The Port is seeking non-material variations to the project’s Marine Construction Licence in accordance with section 30(7) of the Marine Scotland Act 2010. This document sets out the details of the requested variations and explanation of their non-material nature.

Document ID 400.DWT/Docs/SPA/Marine Licensing	Date Revised 27-08-24	Review date N/A	Page No. Page 1 of 9
---	---------------------------------	---------------------------	--------------------------------

DEEP WATER TERMINAL PROJECT**REQUEST FOR NON MATERIAL VARIATION TO MARINE CONSTRUCTION LICENCE****APPENDIX 1****INDICATIVE DETAILS OF FLOATING LINKSPAN**

LINKSPAN
ROCK BREAKOUT
GENERAL ARRANGEMENT

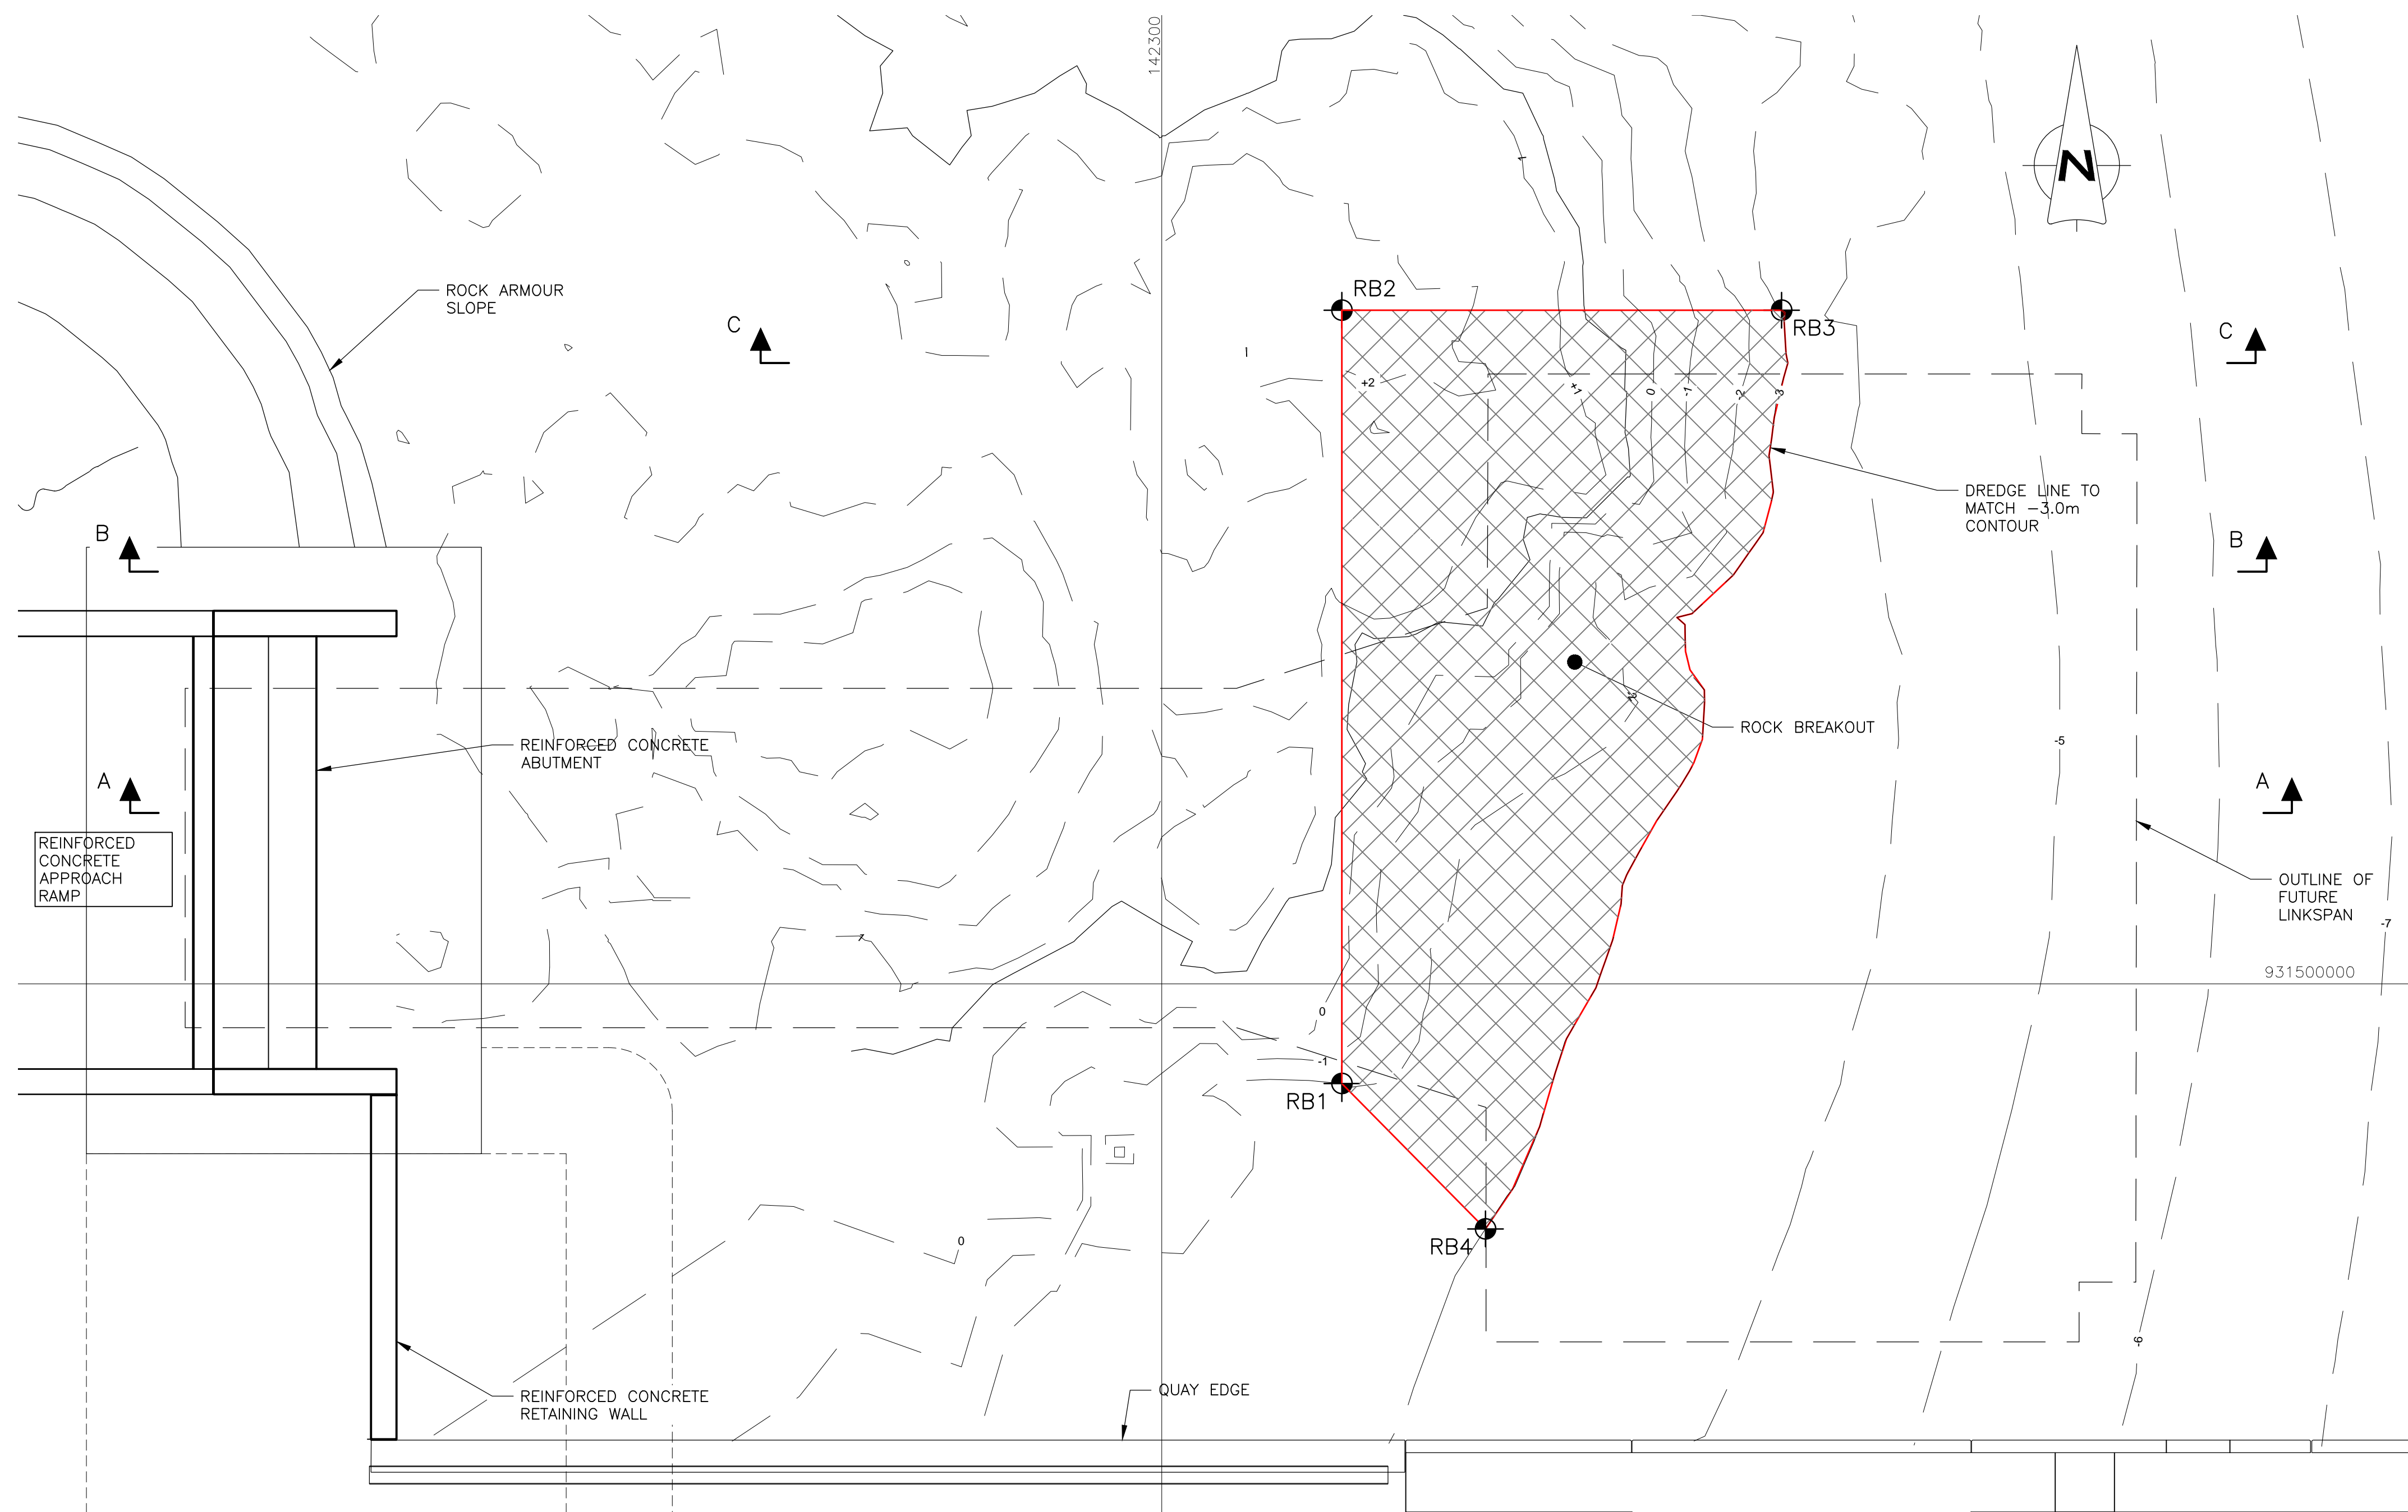
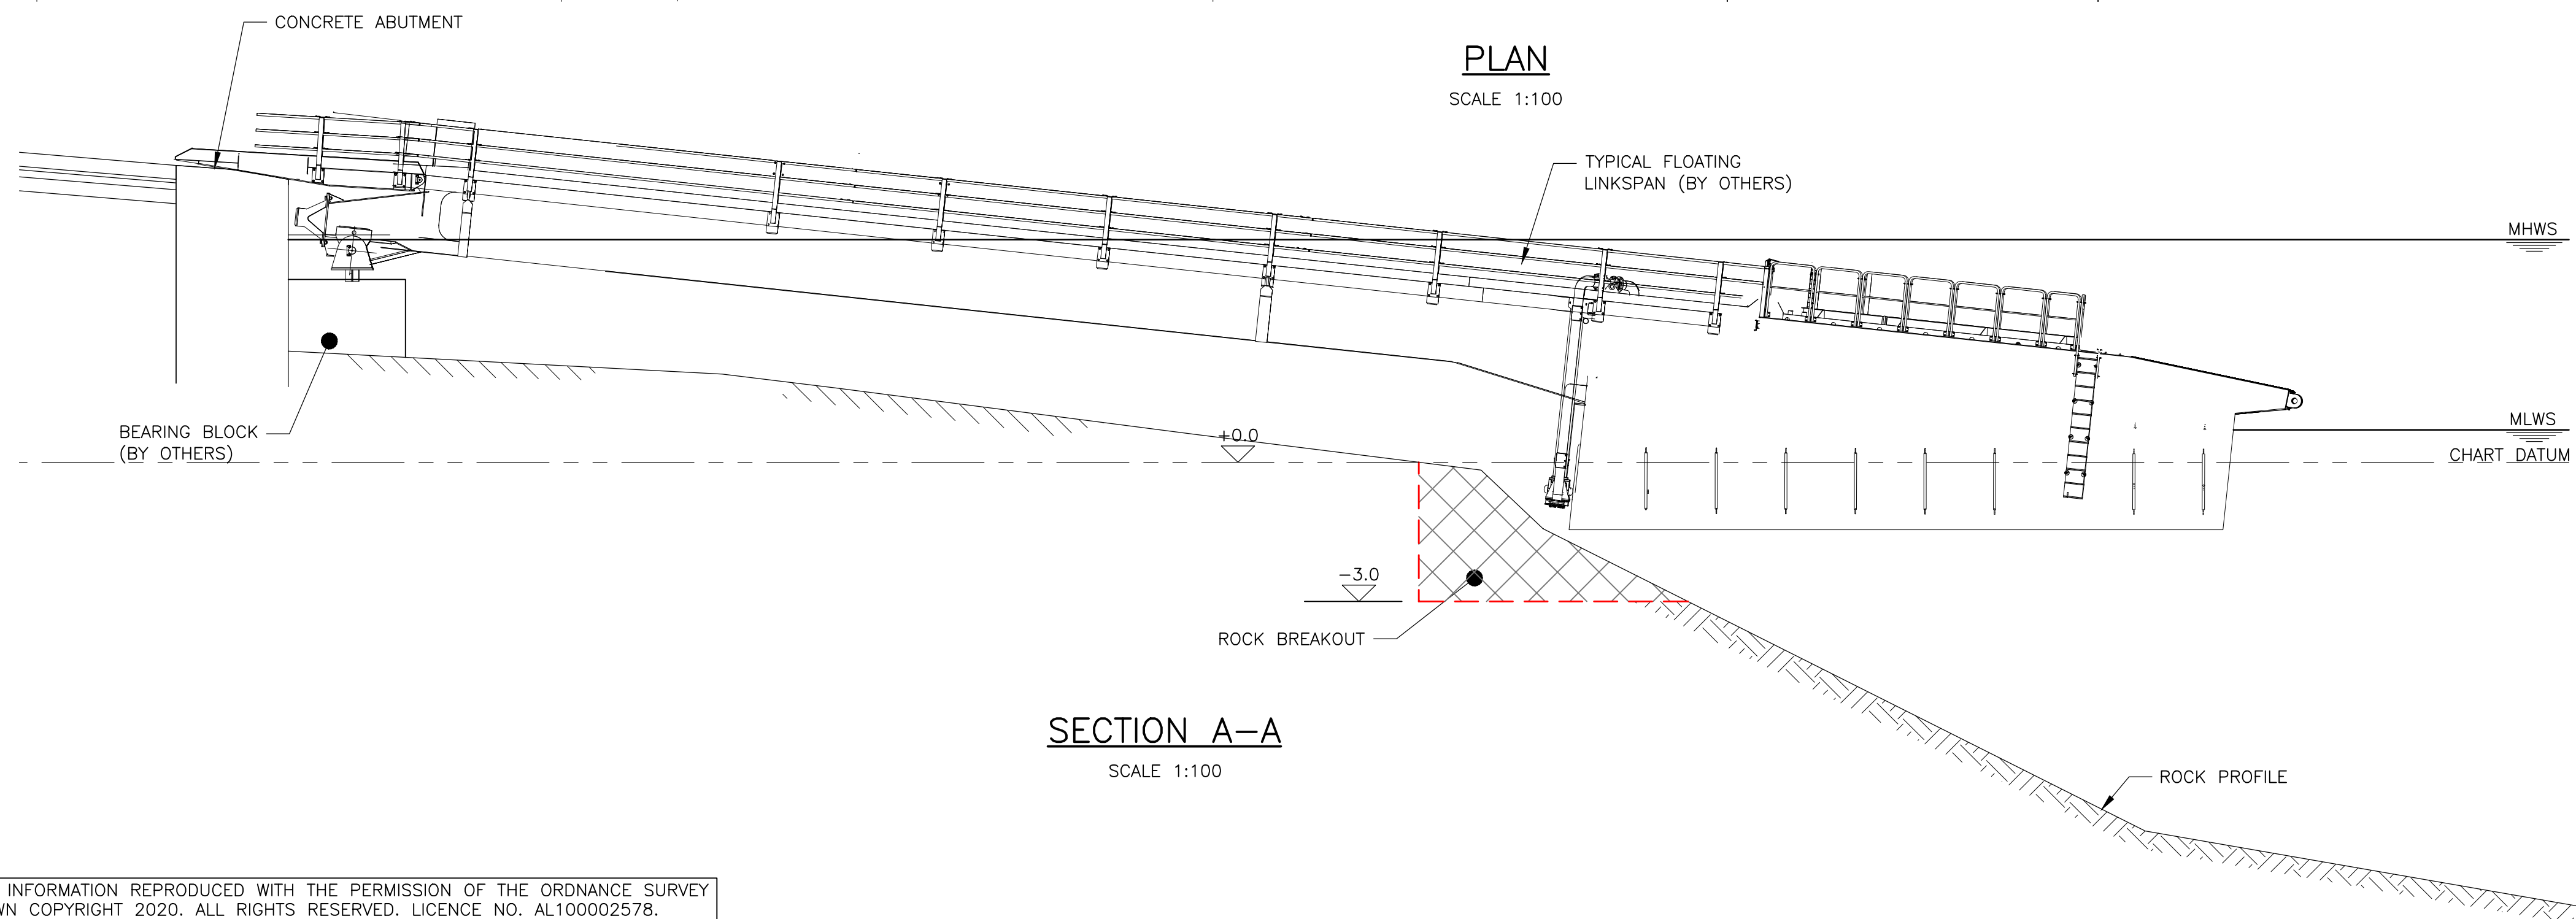
In order to accommodate the buoyancy tank, the bed level at the buoyancy tank location requires to be at least -3.00mCD. A small area of rock (approximately 157m² in area) is above this level. This rock requires to be removed to facilitate the installation of a floating linkspan.

The drawings in Appendix 3 (SDWP-WS2139-XX-00-DR-C-9087 P01 and SDWP-WS2139-XX-00-DR-C-9088 P0) provide a detailed plan and sections of the rock removal area.

The quantity of rock required to be removed has been calculated as 200m³. Allowing 25% for overbreak achieves a total quantity for removal of 250m³. However, the exact quantity of rock to be removed will be determined by the detailed design of the linkspan float. Therefore, the proposed quantity for the purpose of the application for variation of the construction licence is 300m³.

It is proposed to remove this rock by splitting it with a hydraulic breaker then removing the material with an excavator mounted on a temporary bund of crushed rock comprised of material from the Stornoway Deep Water Terminal works. The estimated duration of this work is one to two weeks.
